APPEAL	SUMMARY
/ (I I L / (L	0011111/0111

Appeal ID: 16070	Project Address: 826 SE 3RD Ave
Hearing Date: 11/1/17	Appellant Name: Ben Carr
Case No.: B-015	Appellant Phone: 9173997101
Appeal Type: Building	Plans Examiner/Inspector: Natalie Davis
Project Type: commercial	Stories: 6 Occupancy: F-2, M Construction Type: I-A, III-A
Building/Business Name: THE TREE FARM	Fire Sprinklers: Yes - THROUGHOUT
Appeal Involves: Erection of a new structure	LUR or Permit Application No.: 17-196429-CO
Plan Submitted Option: pdf [File 1] [File 2] [File 3]	Proposed use: F-2, M

BUILDING CODE APPEAL - SECTION 1406.2 THE TREE FARM - 826 SE 3RD AVE BRETT SCHULZ ARCHITECT

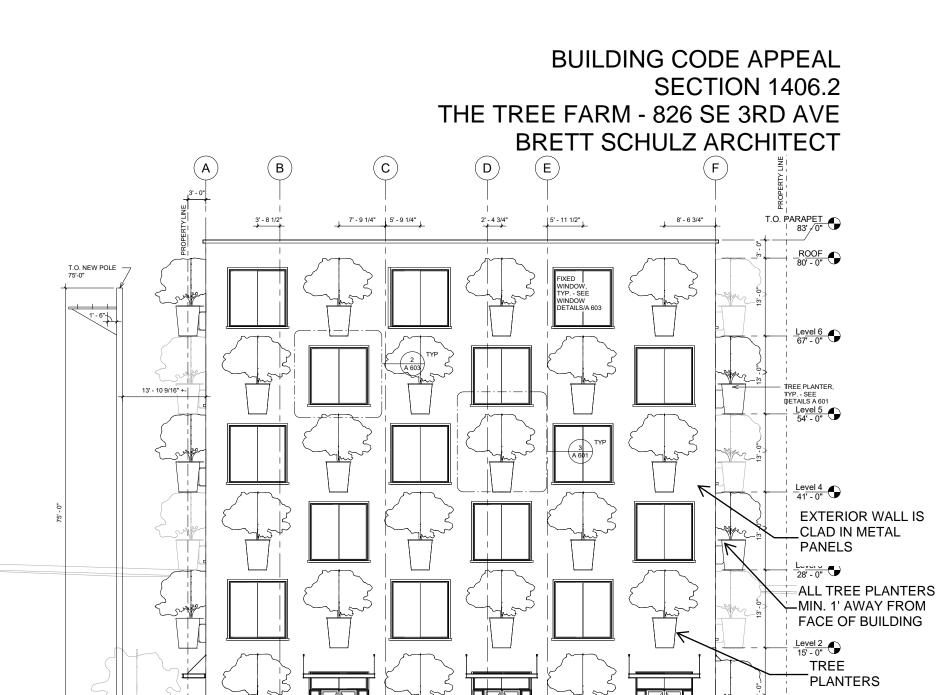
Code Section	1406.2.1.2
Requires	Combustible Exterior Wall Coverings shall comply with this section. On buildings of Type III construction, exterior wall coverings shall be permitted to be constructed of combustible materials complying with the following limitations:
	Combustible exterior wall coverings shall be limited to 40 feet in height above the grade plane.
Proposed Design	The Tree Farm is designed as a 6 story "5-over-1" building, with level 1 to be Type IA construction and levels 2-6 to be Type IIIA construction. On the exterior of the building there are tree planters, with 54 on levels 2-6 and 6 on the ground floor. The planters are constructed of steel plate, rolled into a tapered cylinder form that is then welded to plate steel which is in turn bolted to a cantilevered knife plate that is welded to a steel post within the exterior building wall. The closest edge of the planter is set 1'-0" away from the exterior face of the exterior wall. The exterior wall is constructed of 2x6 fire-retardent-treated wood studs, with fire-retardent-treated plywood sheathin and a 5/8" layer of Type X GWB on the interior side. On the exterior face of the plywood sheathin will be a rain screen system, with metal panels forming the outermost layer. The exterior wall assembly is independent of the tree planter, and it is the appellant's position tha the tree planter should not be considered a part of the Exterior Wall Covering, and therefore not subject to the limitations of 1406.2.1. Per the OSSC Definitions chapter, an Exterior Wall Covering is "a material or assembly of materials applied on the exterior side of exterior walls for the purpos

of providing a weather-resisting barrier, insulation or for aesthetics, including but not limited to veneers, siding, exterior insulation and finish systems, architectural trim and embellishments such as cornices, soffits, facias, gutters and leaders." Because these tree planters are cantilevered from
	the exterior face of the building, and are not applied to the exterior face of the wall as a covering, the appellant believes that the tree planters should not be considered an exterior wall covering.

The exterior wall has its own exterior wall covering via metal panels, and the cantilevered tree planters are a separate, independent element.

Reason for alternativePer communication with the fire marshal's office, the plans examiner has requested this appeal as
part of plan check. The appellant proposes that the requirements of 1406.2.1.2 do not apply,
because the tree planters are not an exterior wall covering. It is the design team's intention to keep
the trees alive and healthy with scheduled irrigation and pruning, as well as to prevent there being
a fire risk from dry or dead foliage touching the exterior face of the wall.
In the event that the trees are to be considered an exterior wall covering, Section 1406.2.1.2
allows for combustible materials to be used in the exterior wall coverings of Type I and Type III
construction up to a height of 40 feet above the grade plane. This would preclude the current
checkerboard design of trees, in which there are trees up to a height of approximately 80'.
However, the appellant believes that the trees should not be considered an exterior wall covering,

and therefore not subject to the 40' height limit, because the exterior wall has its own complete
assembly with metal panels as the exterior face.

Combustible exterior wall coverings above 40 feet in Type III construction: Denied. Proposal does not provide equivalent Life Safety protection.
